City Planning Department

Memo

To: Cranston City Plan Commission
From: Doug McLean, AICP - Principal Planner
Date: December 3, 2021
Re: **“Comstock Industrial”** Master Plan - Major Land Development

Owner/App: Comstock Industrial, LLC
Location: Comstock Parkway, AP 36, Lot 46
Zone: M-1 (Restricted industry)
FLU: Industrial

SITE PLAN (snippet)

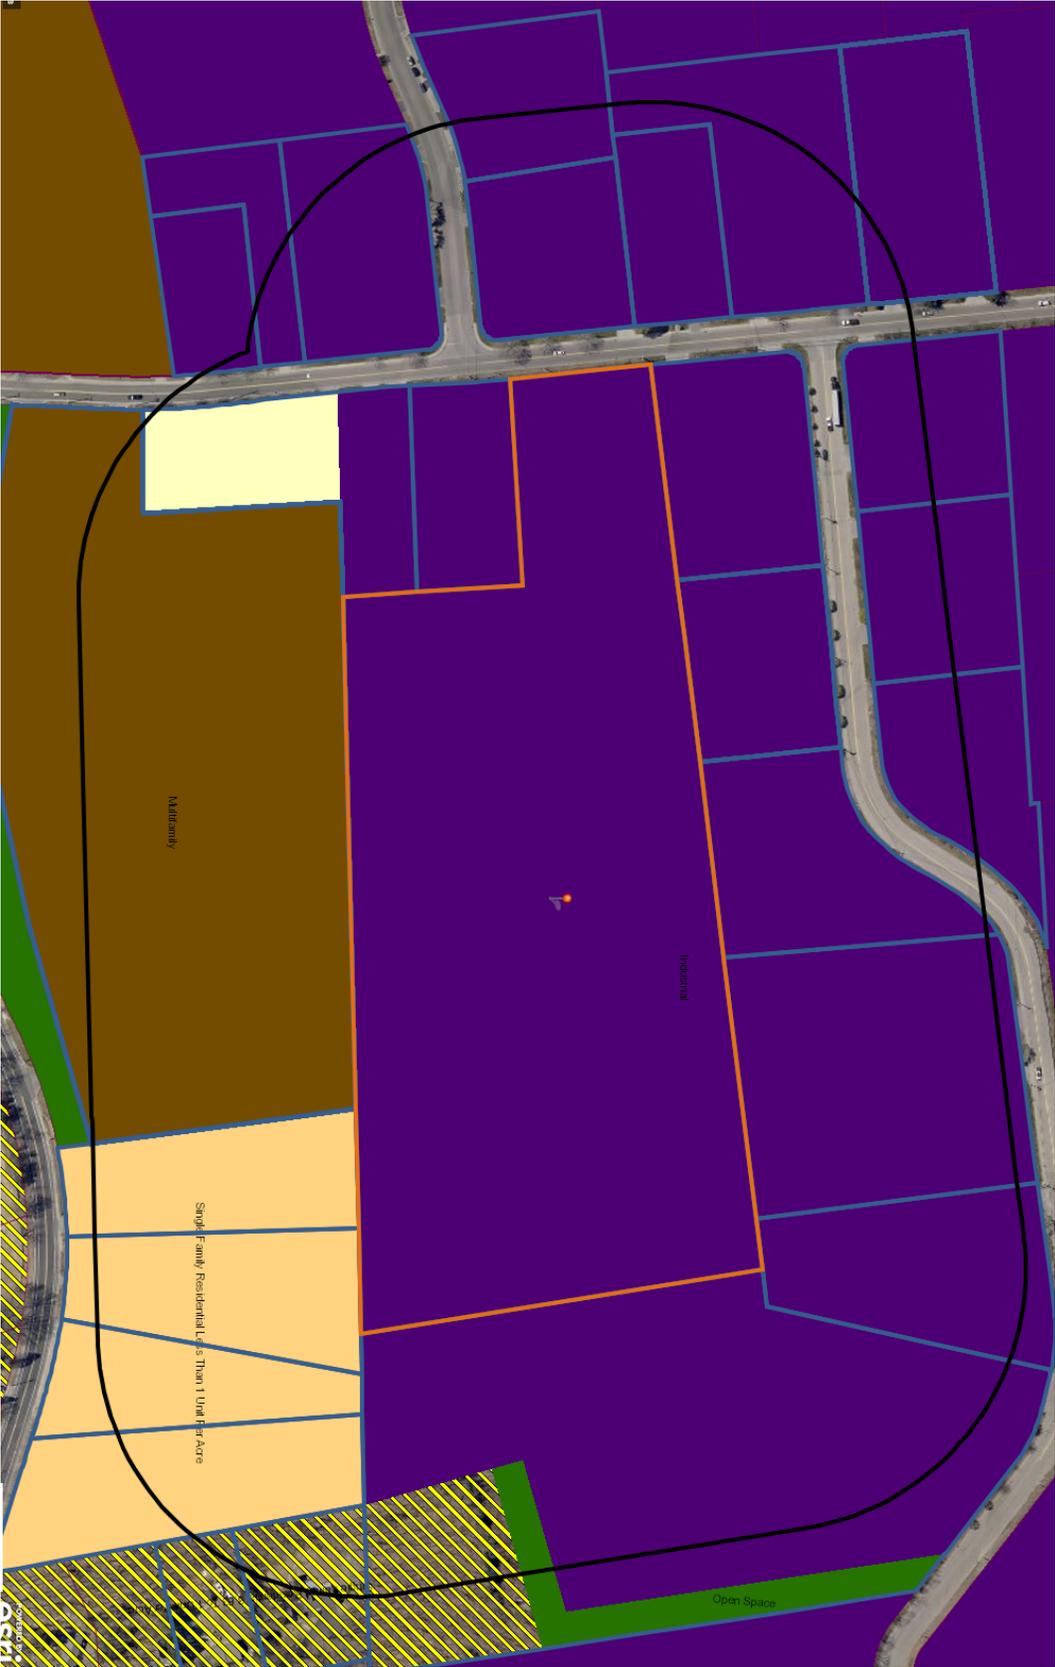
- The City Director of Public Works provided the following comment: *The applicant should revise the entry driveway to increase the turning radius so that trucks leaving the subject property in a northbound direction do not need to make a wide turn into the southbound lane. This revision should be made prior to the Preliminary Plan submission.*

- The City Fire Department provided the following comment: *The Fire Department would like full access to the corners of the proposed buildings and that these areas should be free of obstructions. The Fire Department requests that such changes be made prior to the Preliminary Plan submission.*
